PROW/ADA: R404.7.1, R404.7.2, R209.1,
MUTCD 4e.10

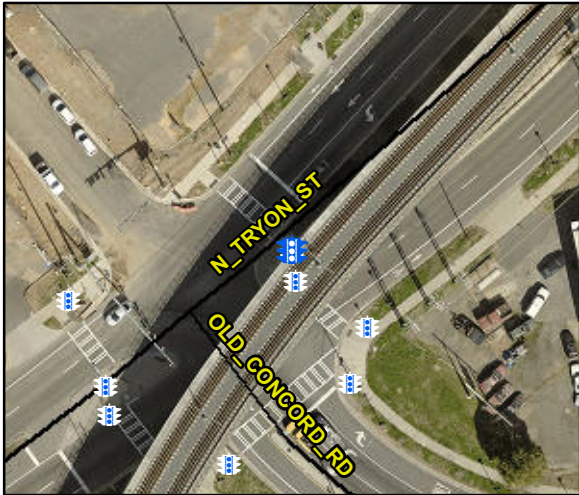
Compliance	Description	Data	Compliance	Description	Data
	Button Count	Button1	Yes	Distant to Additional Button (in)	165.0
	Additional Button Present?	Yes		Additional Button ID	7B807EA1E731
N/A	Signal Buttons Required?	N/A	N/A	Additional Ped Posts Required	N/A
	How Many Ped Street Xings?	2		Located In An Island/Median?	Yes
N/A	B 1 Sign Present?	Yes	N/A	B 2 Sign Present?	N/A
Yes	B 1 Sign Purpose?	Yes	N/A	B 2 Sign Purpose?	N/A
Yes	B 1 Sign Lettering & Contrast?	Yes	N/A	B 2 Sign Lettering & Contrast?	N/A
Yes	B 1 Parallel To XWalk?	Yes	N/A	B 2 Parallel To XWalk?	N/A
Yes	B 1 PAR to Button?	Yes	N/A	B 2 PAR to Button?	N/A
Yes	B 1 PAR to XWalk?	Yes	N/A	B 2 PAR to XWalk?	N/A
Yes	B 1 Clear Floor Space?	Yes	N/A	B 2 Clear Floor Space?	N/A
No	B 1 FWD Approach?	No	N/A	B 2 FWD Approach?	N/A
N/A	B 1 FWD Approach Constrained?	No	N/A	B 2 FWD Approach Constrained?	N/A
N/A	B 1 FWD Approach Reach (in)	18.0	N/A	B 2 FWD Approach Reach (in)	N/A

N/A	B 1 FWD Approach Width (in)	60.0	N/A	B 2 FWD Approach Width (in)	N/A
N/A	B 1 FWD Approach Obstruction?	Yes	N/A	B 2 FWD Approach Obstruction?	N/A
N/A	B 1 FWD Approach Obstruction Dist (in)	16.0	N/A	B 2 FWD Approach ObstructionDist (in)	N/A
No	B 1 PARA Approach?	No	N/A	B 2 PARA Approach?	N/A
N/A	B 1 PARA Approach Constrained?	No	N/A	B 2 PARA Approach Constrained?	N/A
N/A	B 1 PARA Approach Reach (in)	18.0	N/A	B 2 PARA Approach Reach (in)	N/A
N/A	B 1 PARA Approach Width (in)	60.0	N/A	B 2 PARA Approach Width (in)	N/A
N/A	B 1 PARA Approach Obstruction?	Yes	N/A	B 2 PARA Approach Obstruction?	N/A
N/A	B 1 PARA Approach Obstruction Dist (in)	16.0	N/A	B 2 PARA Approach ObstructionDist (in)	N/A
Yes	B 1 Clear Floor Space Slope (%)	1.3	N/A	B 2 Clear Floor Space Slope (%)	N/A
Yes	B 1 Clear Floor Space XSlope (%)	0.6	N/A	B 2 Clear Floor Space XSlope (%)	N/A
N/A	B 1 PAR Slope (%)	0.5	N/A	B 2 PAR Slope (%)	N/A
Yes	B 1 Height (in)	38.0	N/A	B 2 Height (in)	N/A

Possible Solutions: Remove & Replace
Replace APS Button With New APS Button.
Provide Clear Space.
